PG-FP5 Flash Memory Programmer

Release Note

R20UT0689EJ1300

Rev.13.00

No. 1 Modification of **Cancel** button specification

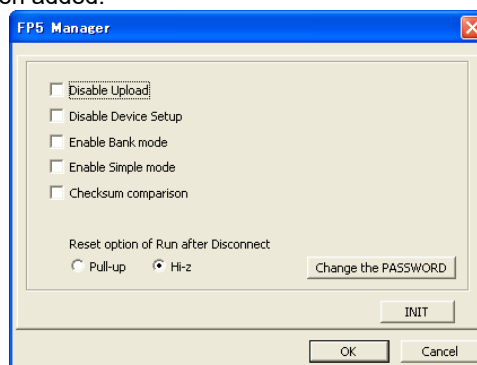
Description: The function of the **Cancel** button on the PG-FP5 main unit has been modified so that cancellation, which was applied to all commands, is only applied to the **Read** command.

Implementation: This item has been implemented in products with control code A (firmware: V1.01, FPGA: V1, GUI: V1.00).

No. 15 Addition of **Wide Voltage mode** function

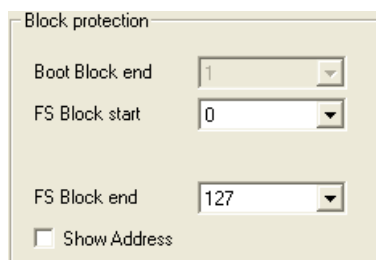
Description: The **Wide Voltage mode** check box has been added to the **Command options** area.

If this check box is selected, commands are executed in the wide voltage mode. If this check box is not selected, commands are executed in the full-speed mode. This check box is available when a device supporting this function is selected. For details about the wide voltage mode and full-speed mode, see the user's manual of each device.

Implementation: This item has been implemented in products with control code A (firmware: V2.02, FPGA: V2, GUI: V2.02).

No. 16 Change of layout in **Block protection** area

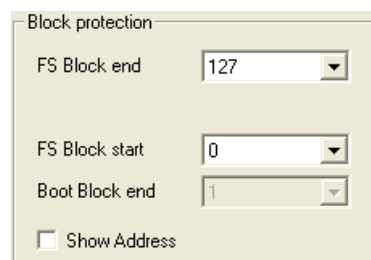
Description: The layout in the **Block protection** area has been changed.

Implementation: This item has been implemented in products with control code A (firmware: V2.02, FPGA: V2, GUI: V2.02).
